Contract No. T201507602.01

BR 3-154 on US9 Savannah Road and BR 3-153 on SR1 Rehoboth Avenue over Lewes-Rehoboth Canal
Sussex County

Enclosed is Addendum No. 3 for the referenced contract consisting of the following:

SE-13
SHEET NO.
127
TOTAL SHTS.
180

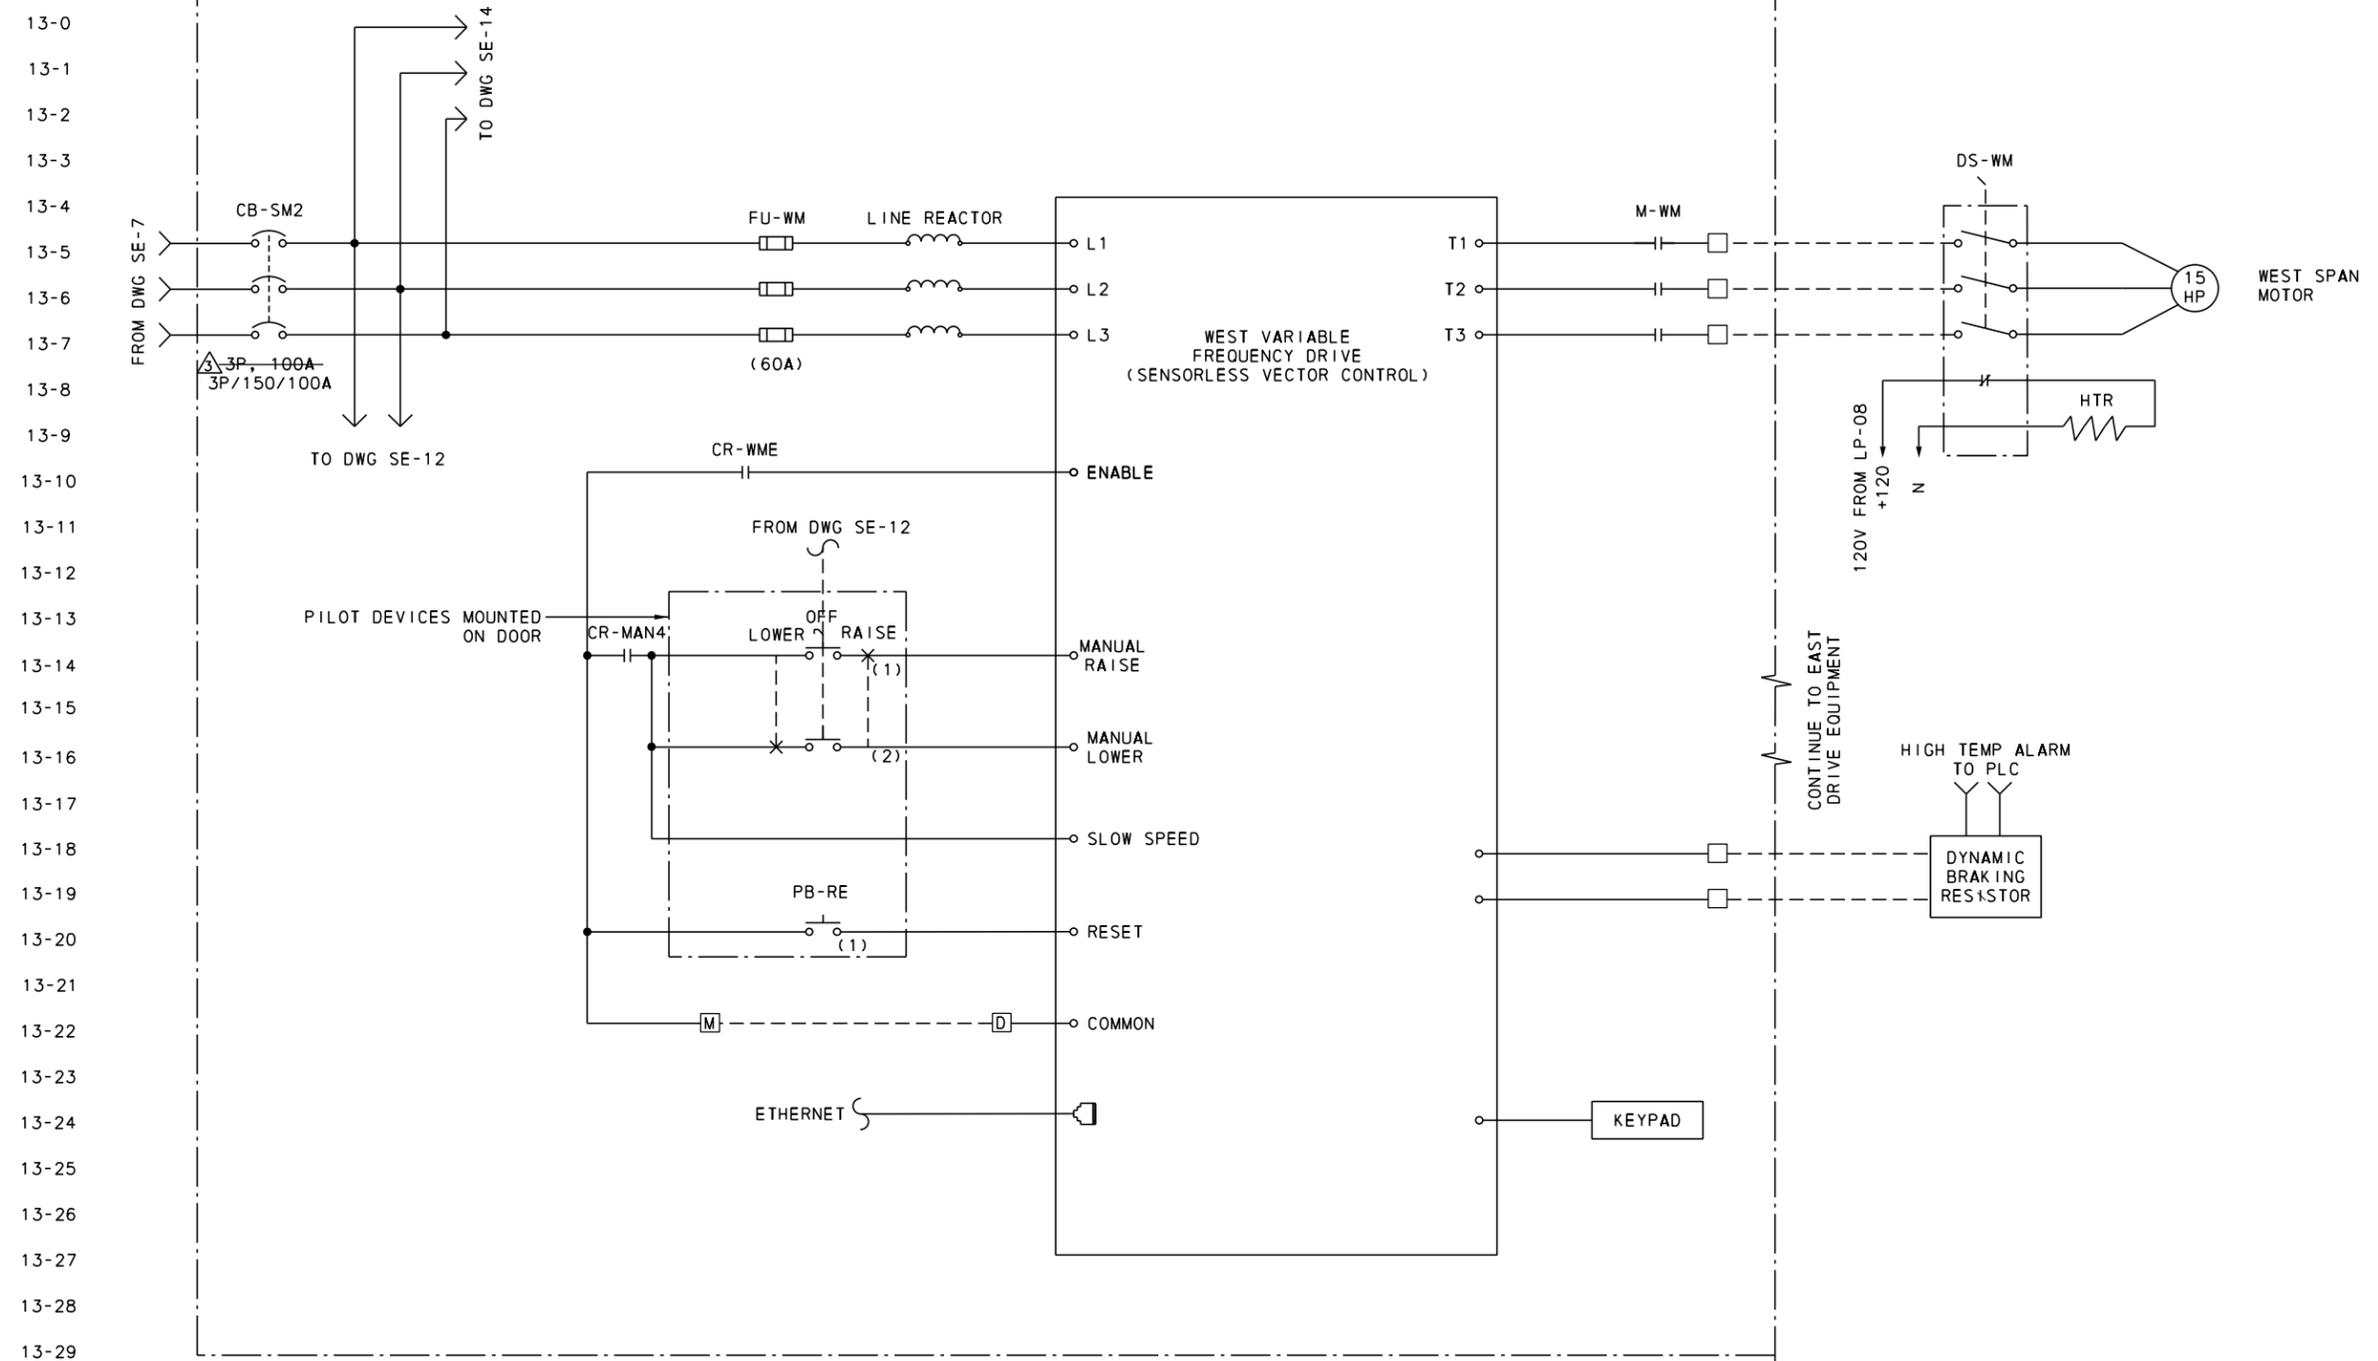
- NOTES:**
1. CIRCUIT BREAKER AND FUSE SIZES SHALL BE MODIFIED PER MANUFACTURER RECOMMENDATIONS.
 2. WIRING TO AND FROM RESISTOR ENCLOSURE SHALL BE HIGH TEMP WIRE.
 3. EACH VFD SHALL OPERATE IN SENSORLESS VECTOR MODE.

ADDENDUMS / REVISIONS	
△	MODIFIED CIRCUIT BREAKER SETTING (MJT 7/23/18)

SE-26
SHEET NO.
140
TOTAL SHTS.
180

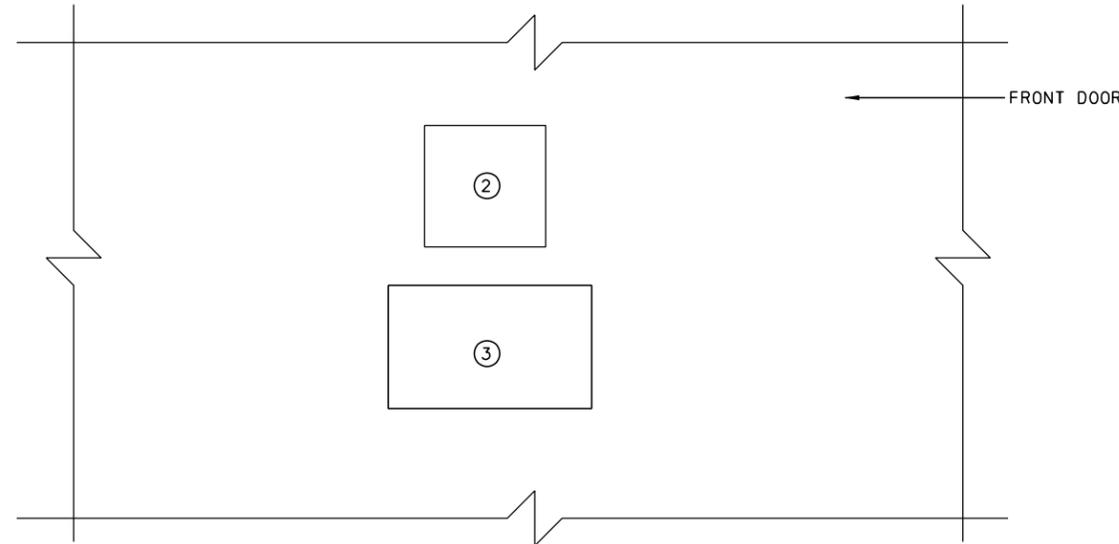
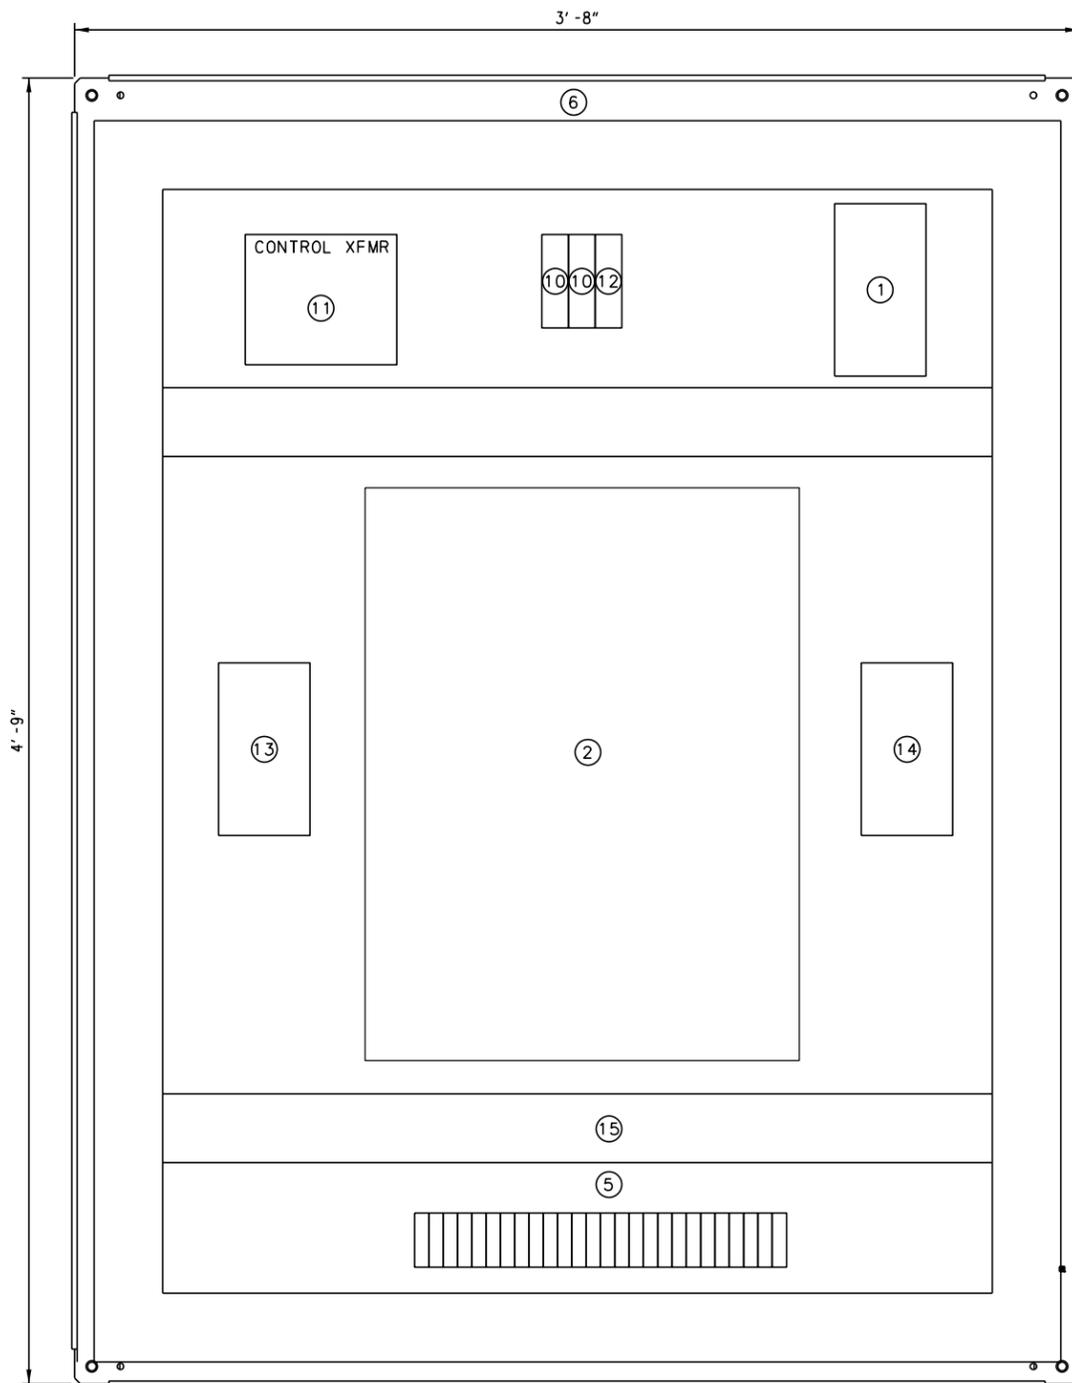
^Δ 3P, 600V, 125AF/60AT, 35KAIC (MIN.)
^Δ 3P, 600V, 125AF/75AT, 35KAIC (MIN.)

^Δ 125AF, 15AT, 35KAIC

^Δ MODIFIED BILL OF MATERIALS & NOTES (MJT 7/23/18)

SE-34
SHEET NO.
148
TOTAL SHTS.
180

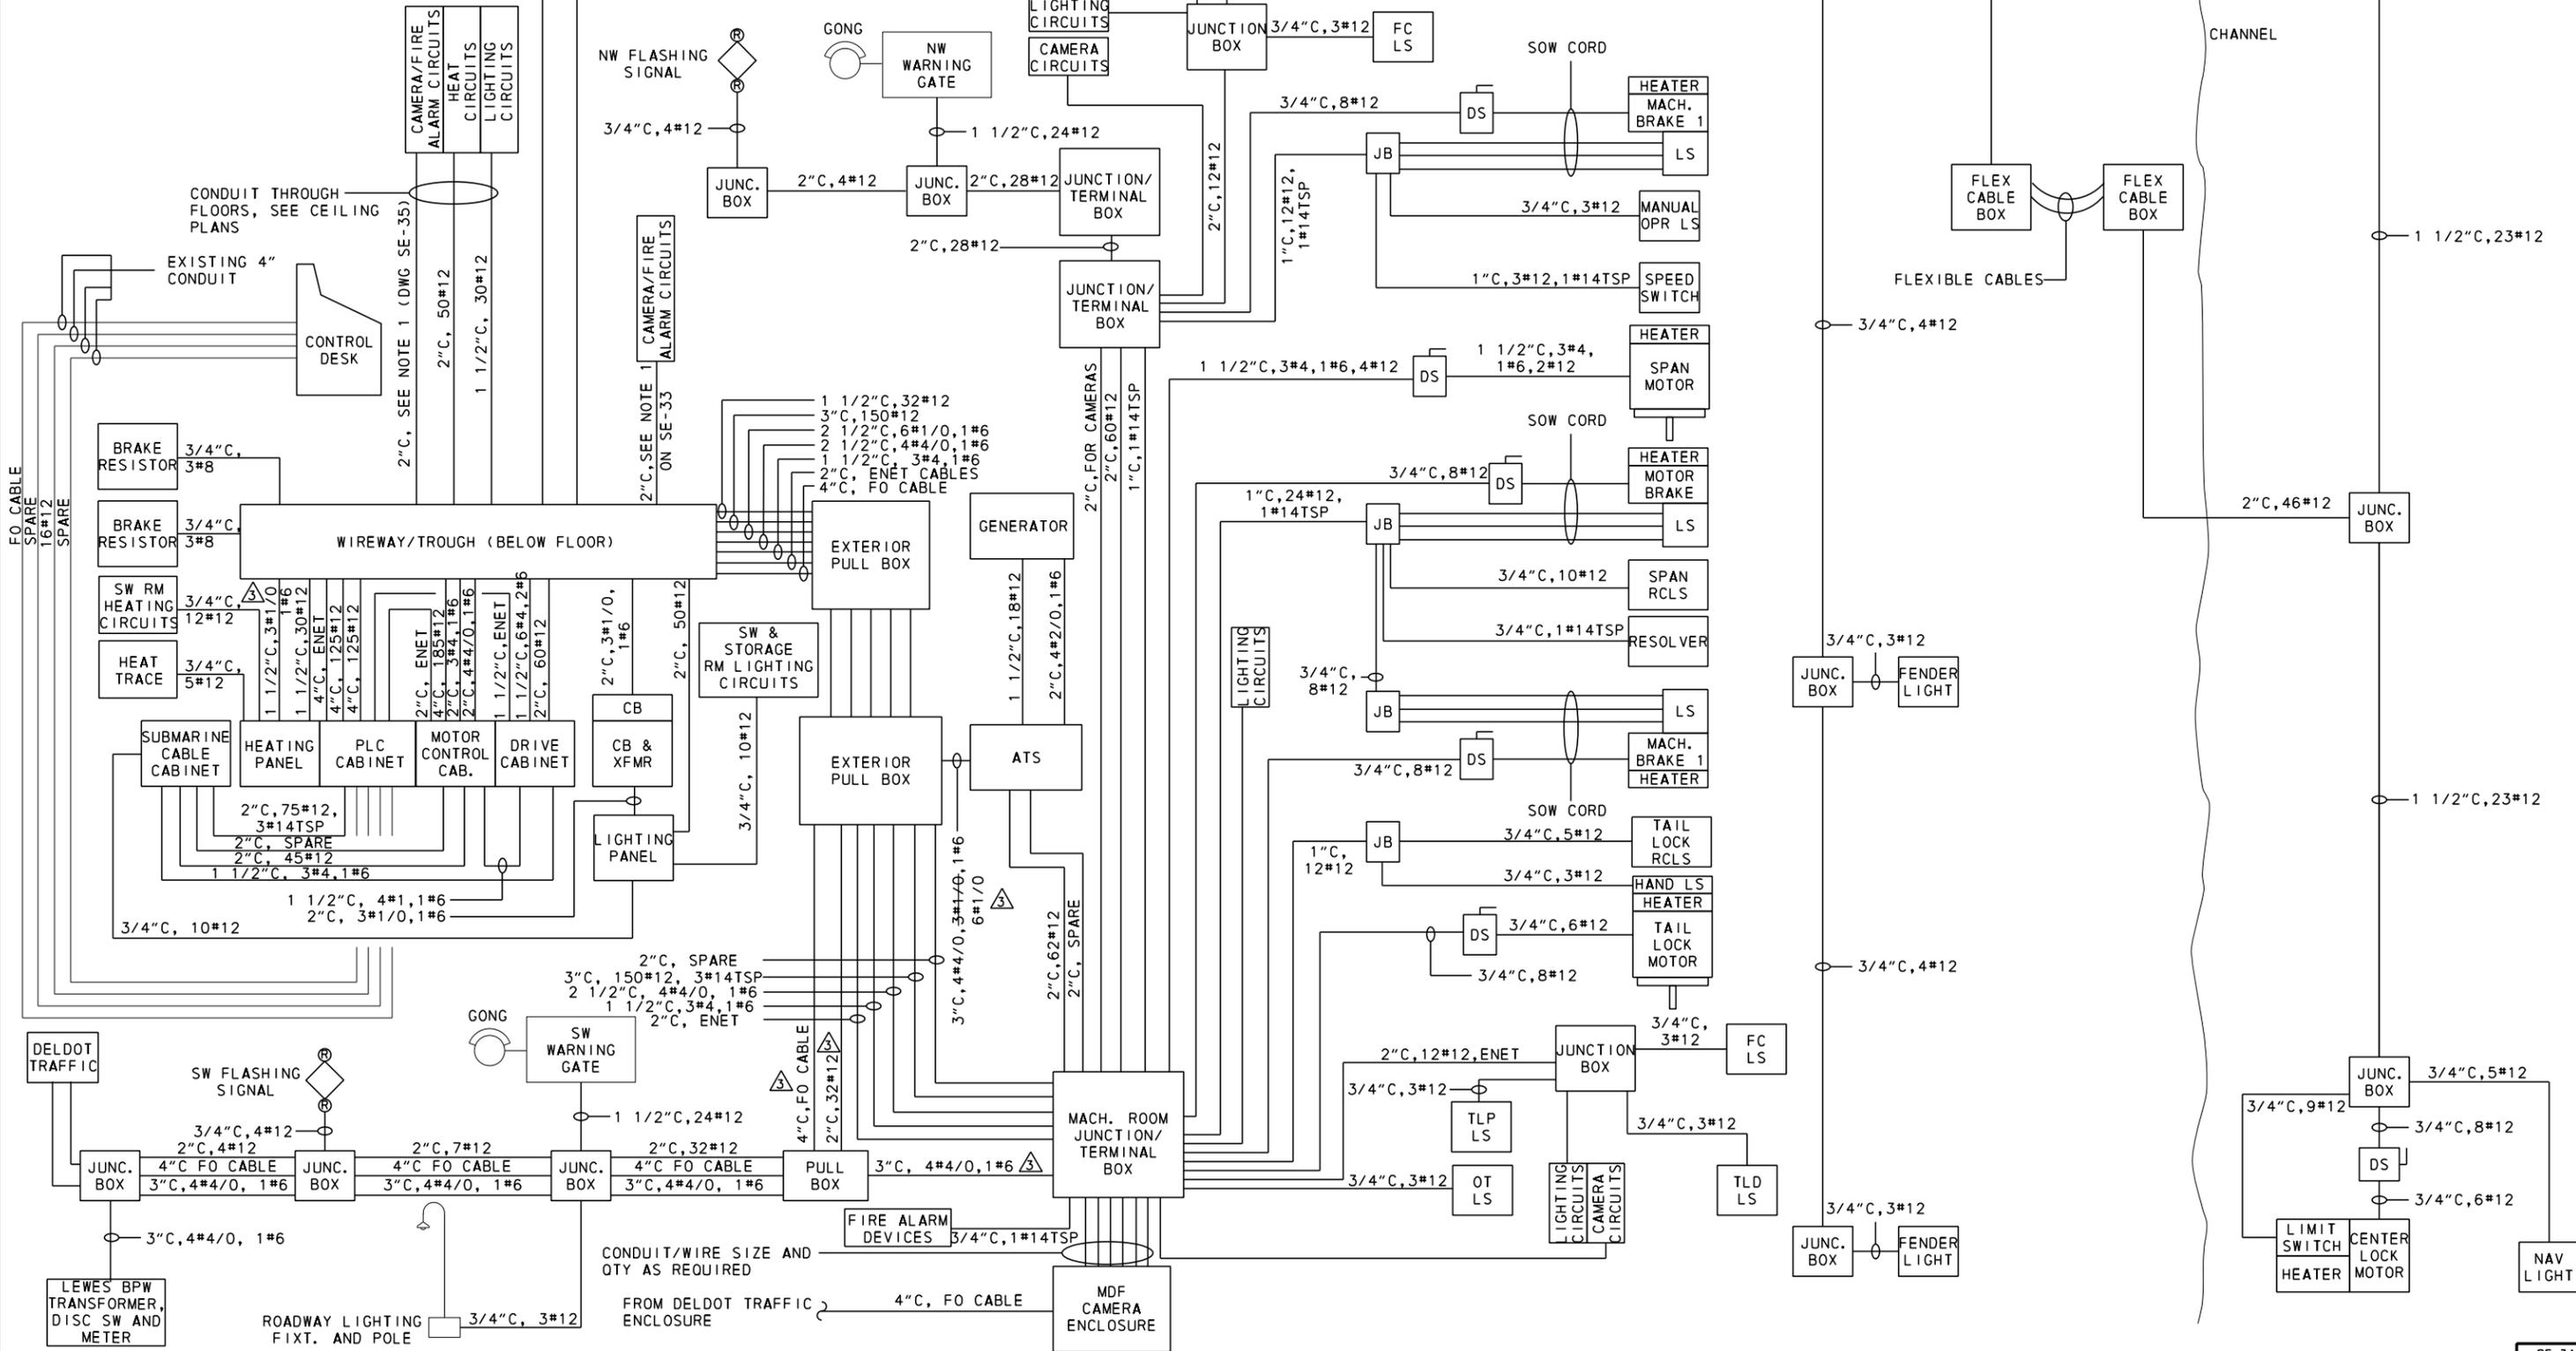
△	ADDED WIRE AND CONDUIT (MJT 7/23/18)
